**KU-RING-GAI LOCAL PLANNING PANEL MEETING
TO BE HELD ON WEDNESDAY, 2 JULY 2025 AT 11:00 AM
BY ZOOM CONFERENCING**

REPORT TITLE:	91 - 93 CARRINGTON ROAD WAHROONGA - DEMOLITION OF EXISTING STRUCTURES, LOT CONSOLIDATION, CONSTRUCTION OF 10 INDEPENDENT LIVING- MULTI DWELLINGS HOUSES, ENGINEERING, LANDSCAPING AND ASSOCIATED WORKS PURSUANT TO PART 5 OF SEPP (HOUSING) 2021
ITEM/AGENDA NO:	GB.1

APPLICATION NO:	EDA0586/24
ADDRESS:	91-93 Carrington Road, Wahroonga
WARD:	Wahroonga
DESCRIPTION OF PROPOSAL:	Demolition of existing structures, lot consolidation, construction of 10 independent living- multi dwellings houses, engineering, landscaping and associated works pursuant to Part 5 of SEPP (Housing) 2021
APPLICANT:	MSV Ultima Pty Ltd
OWNER:	Mr PH Wilson, Mrs ACM Dickinson (at time of lodgement)
DATE LODGED:	13 January 2025
SUBMISSIONS:	Eight
ASSESSMENT OFFICER:	Belinda Newell
RECOMMENDATION:	Refusal

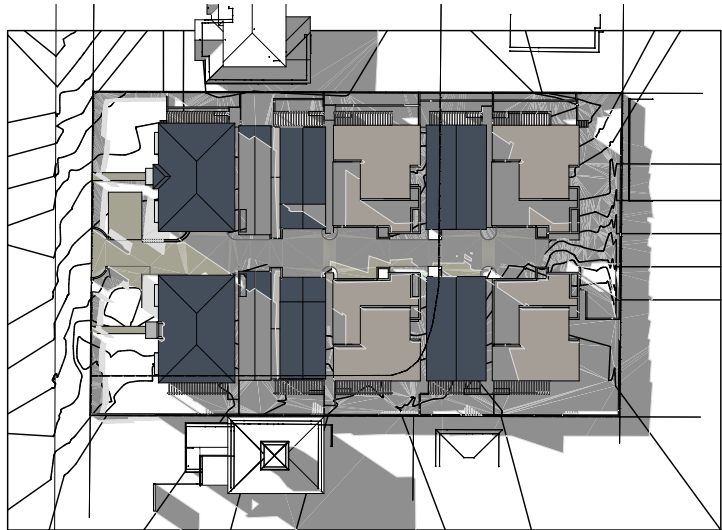
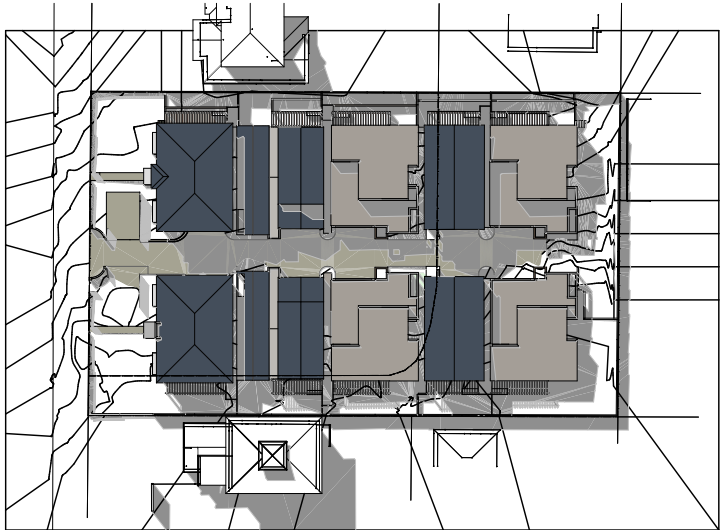
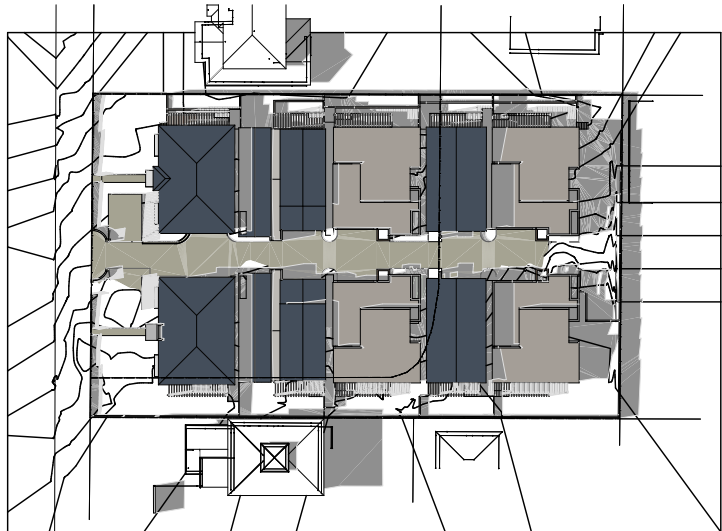
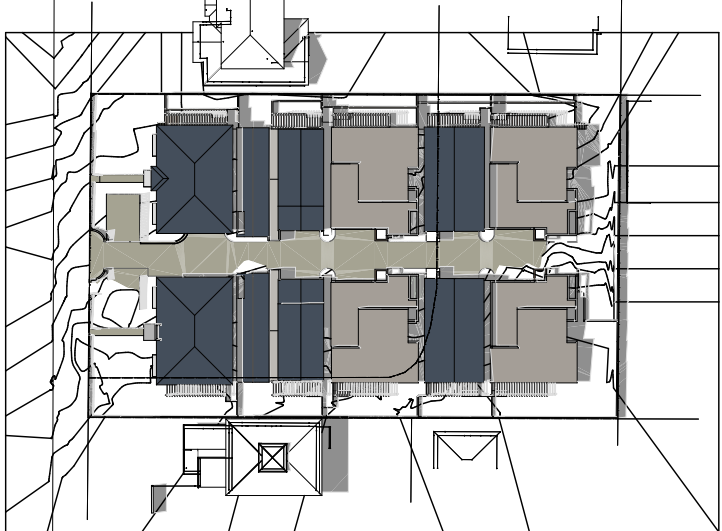
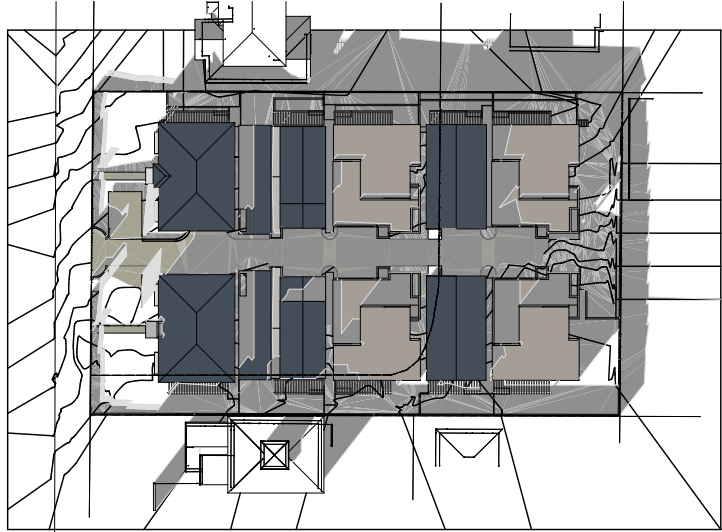
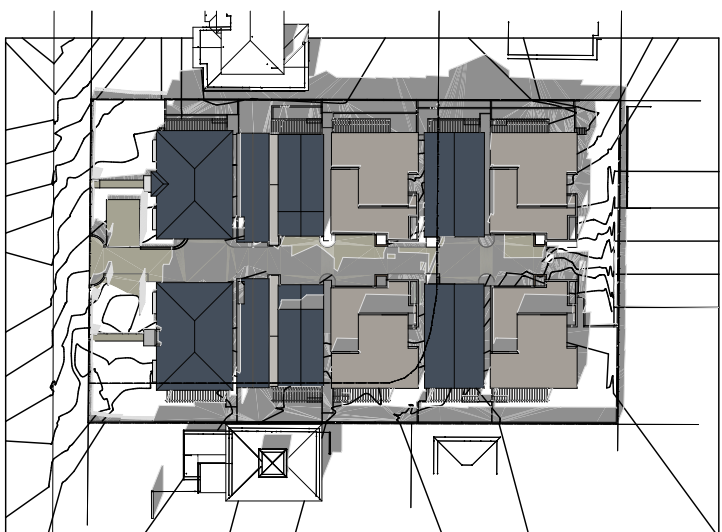
if complied with, prevent the consent authority from requiring more onerous standards. However, an independent assessment in plan using the surveyed true north point and comparison with the solar access diagrams indicates that the solar access modelling may be incorrect by a number of degrees.

Dwg: Landscape Site Plan

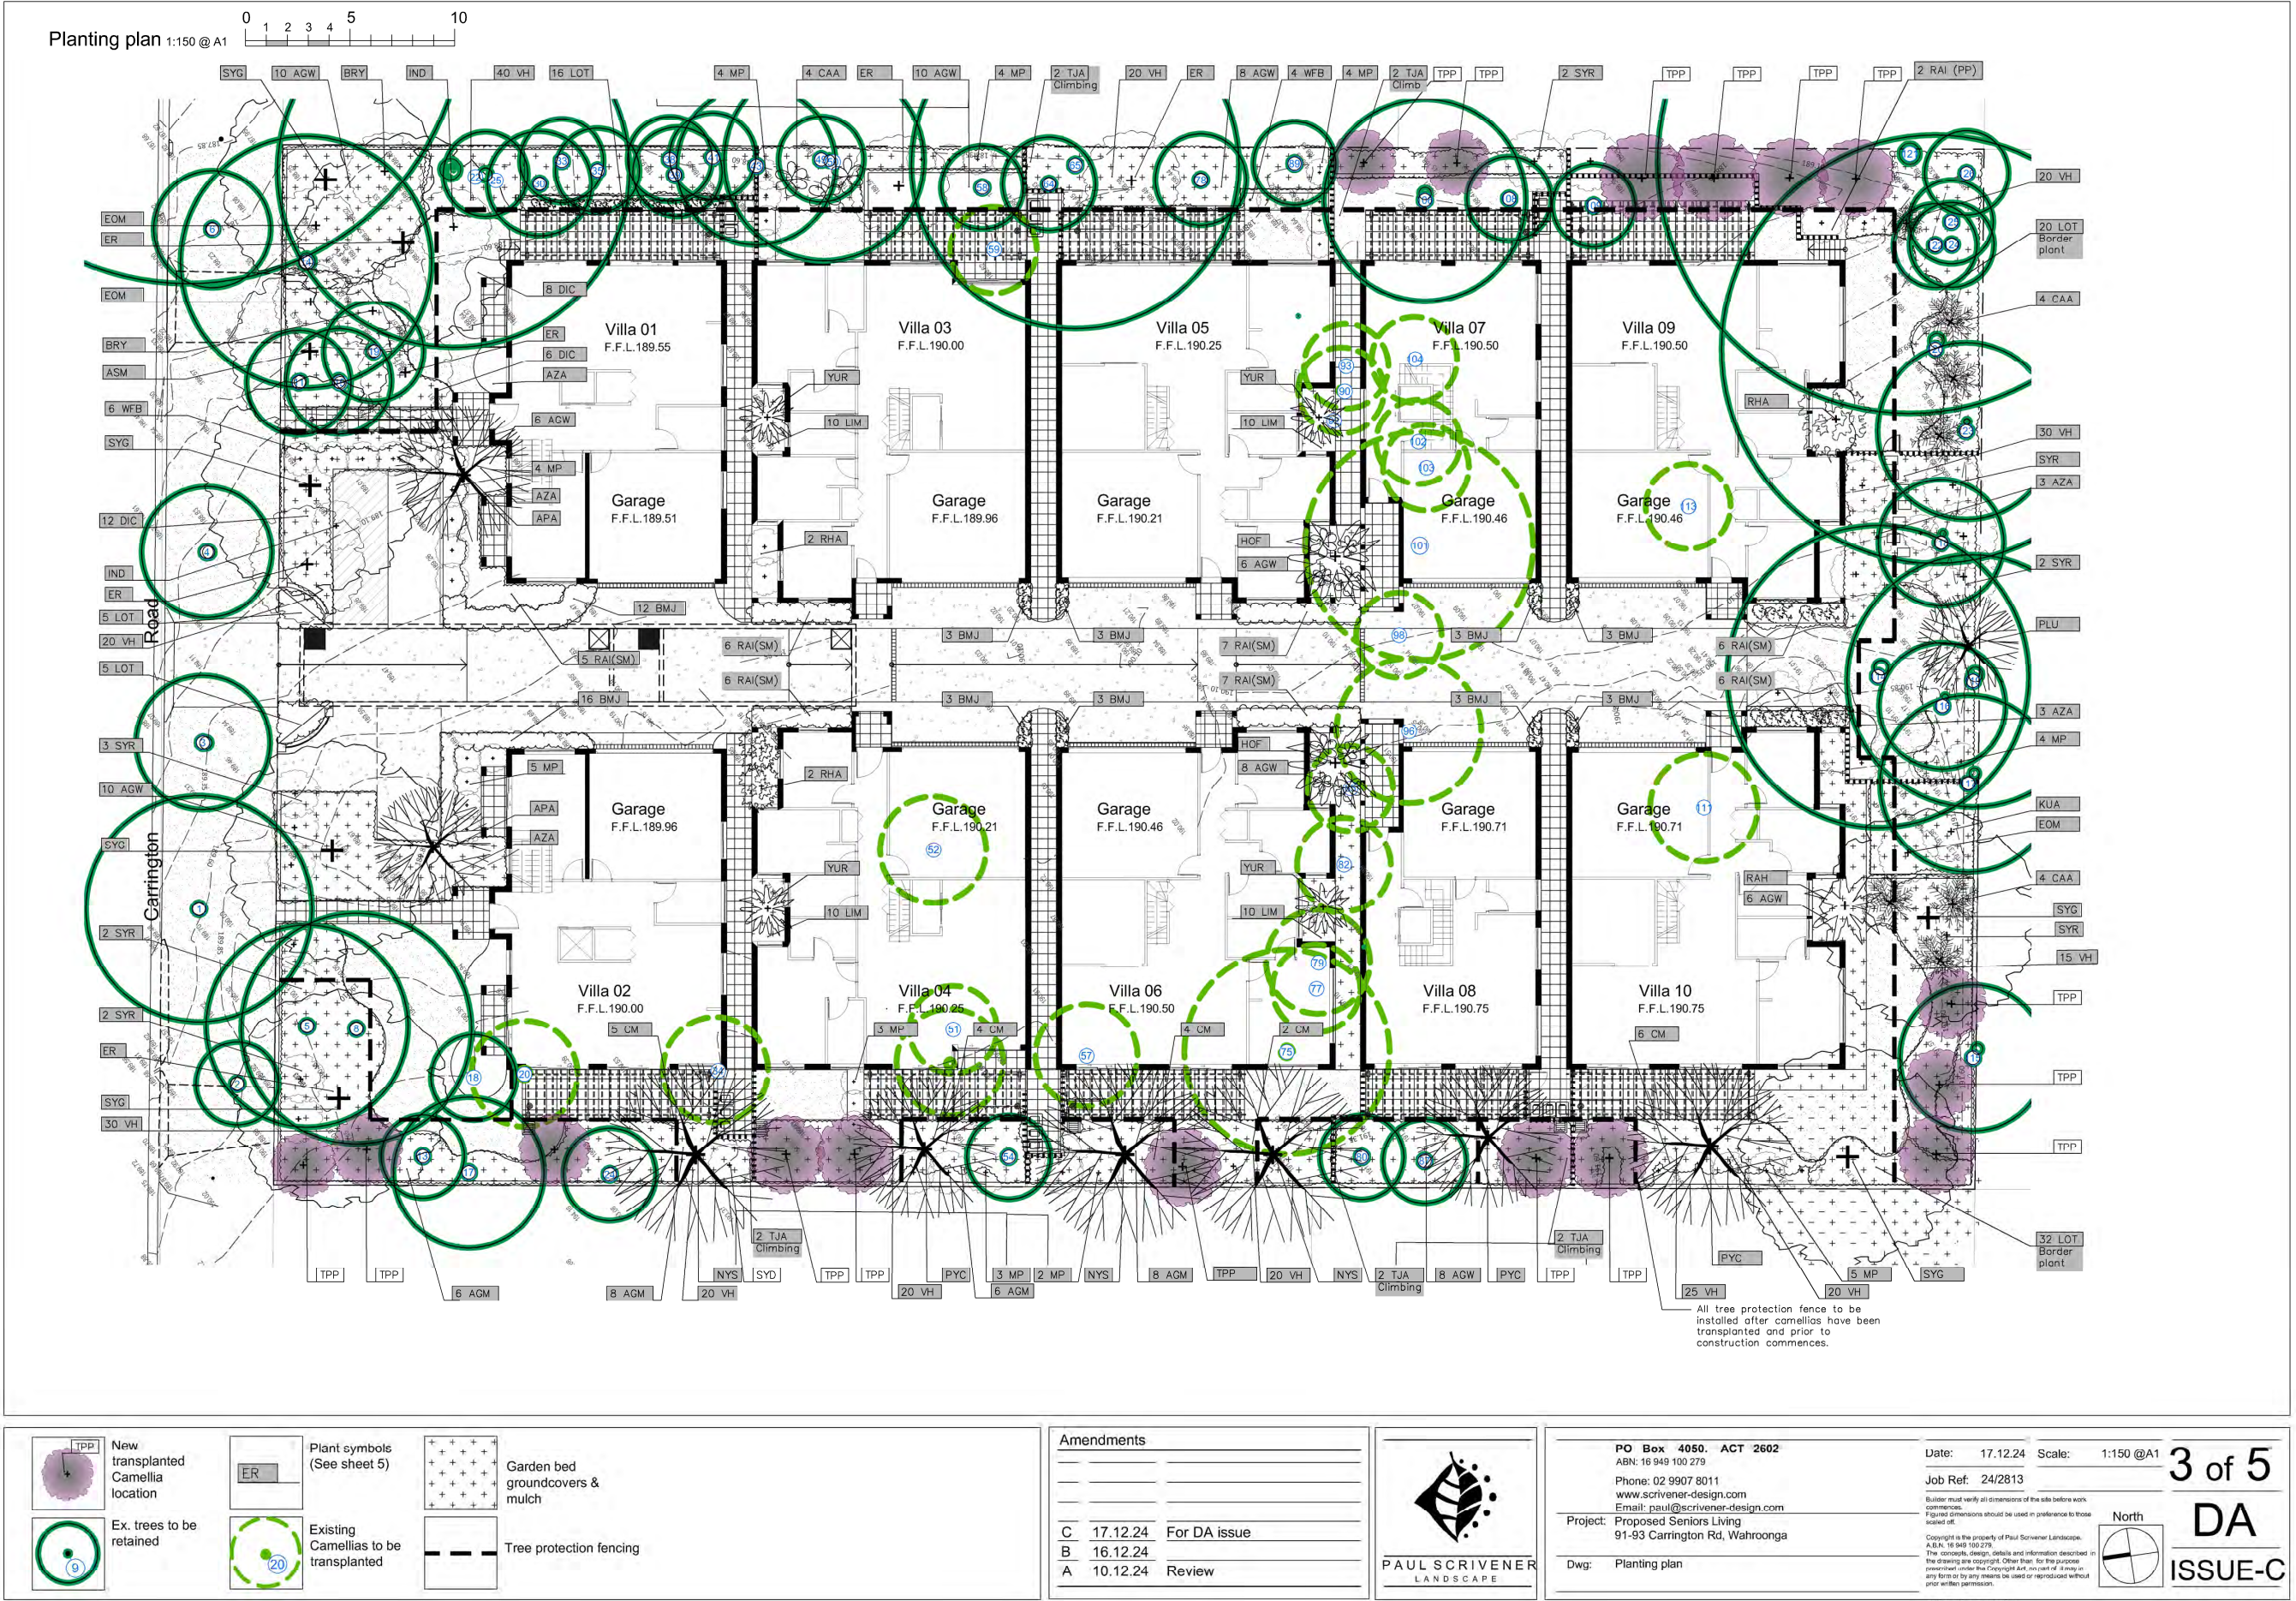
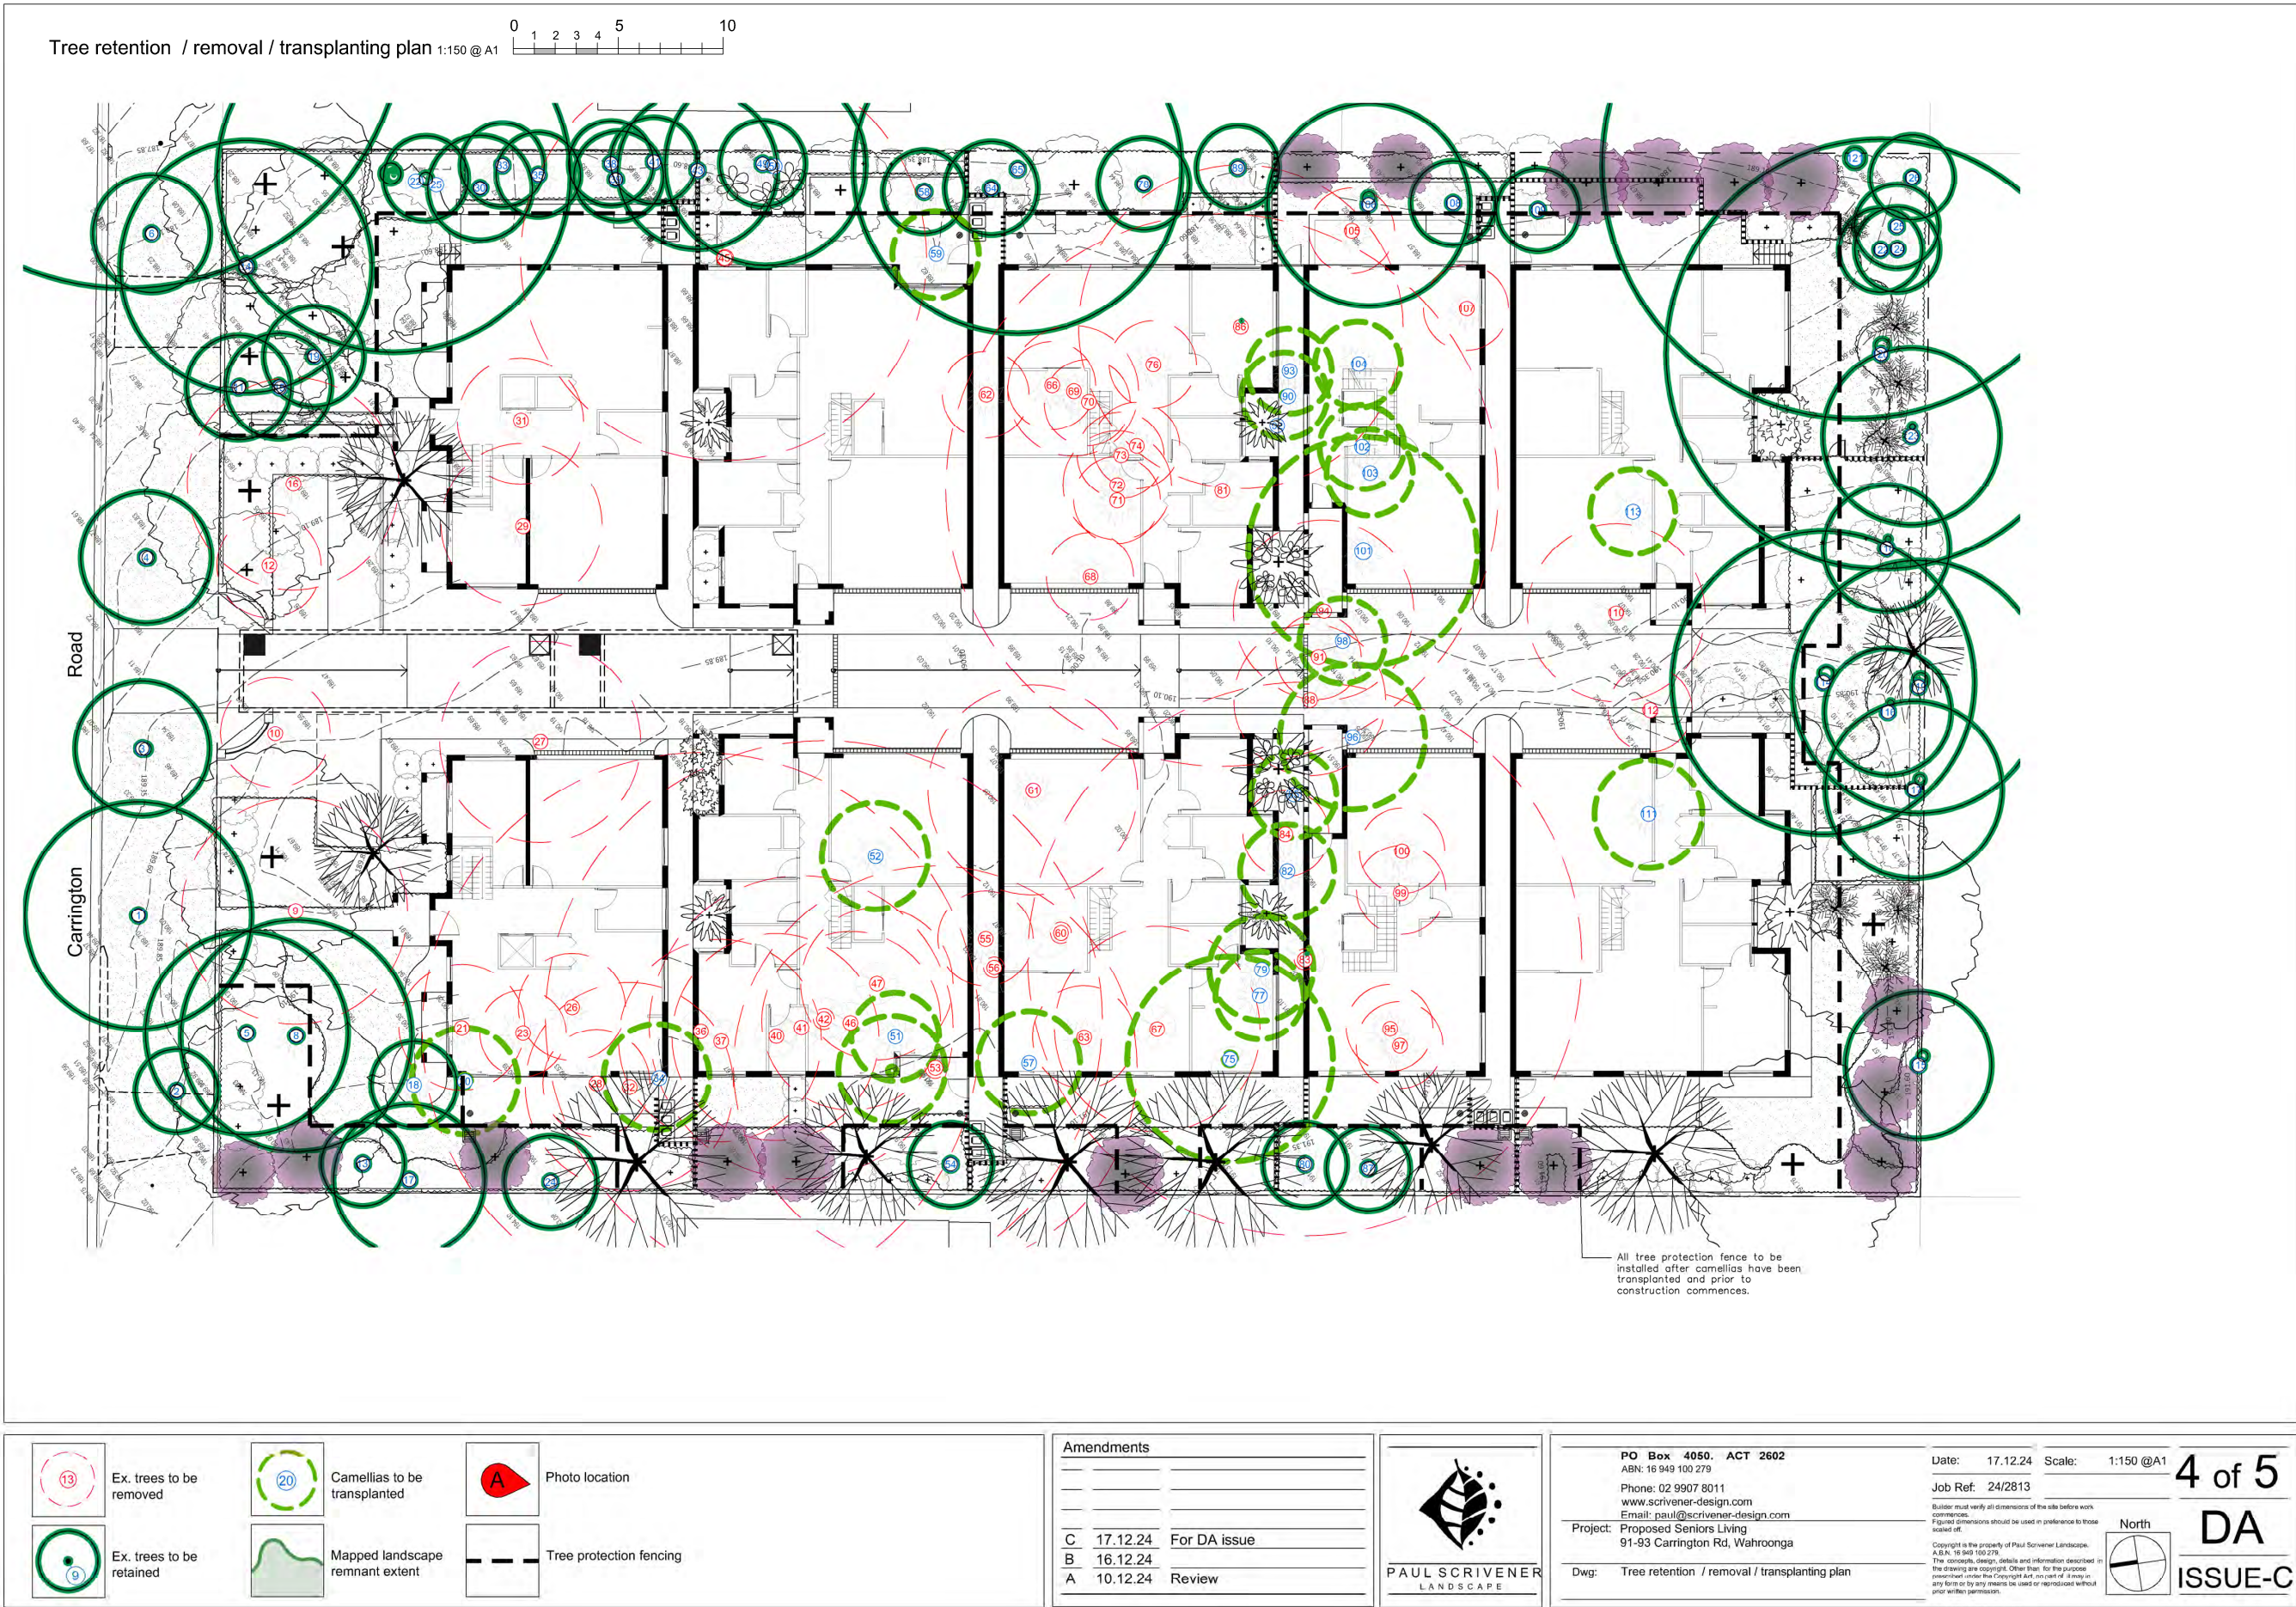
- The proposed transplanting of 3 x Camellia's in the south-west corner as screen planting is not considered viable.
- T116, T118 & T123 located on the southern boundary are recommended for removal as they are either weed species or in poor health. Replacement tree and shrub planting will be required.

<p>21.2 Landscape Design</p> <p>To ensure the landscape design and species selection is suitable to the site its context and considers the amenity of residents and neighbours.</p>	<p>The landscape plan is not acceptable:</p> <ul style="list-style-type: none"> The landscaped area does not satisfy Cl 108(e) of Division 7 of the SEPP (Housing) 2021 in that the landscaped area is <30% of the site. The proposed transplanting of 15 x Camellia's as screen planting is not considered viable. Unless the transplanting is carried out and maintained by specialists, they are unlikely to survive. Inappropriate placement of tall to medium trees beneath the canopies of existing trees to be retained (T22, T114). The proposed front fence adversely impacts on an existing hedge row of Camellia's along the front boundary retained excluding the areas allocated for access. Trees T24, T33, T50, T78, T89, T108, T109, T116, T118, T123 are proposed for retention however should be removed due to poor health, structural instability or are weed species. The proposed retaining walls and associated cut and fill along the eastern, western and southern boundaries will either 	NO
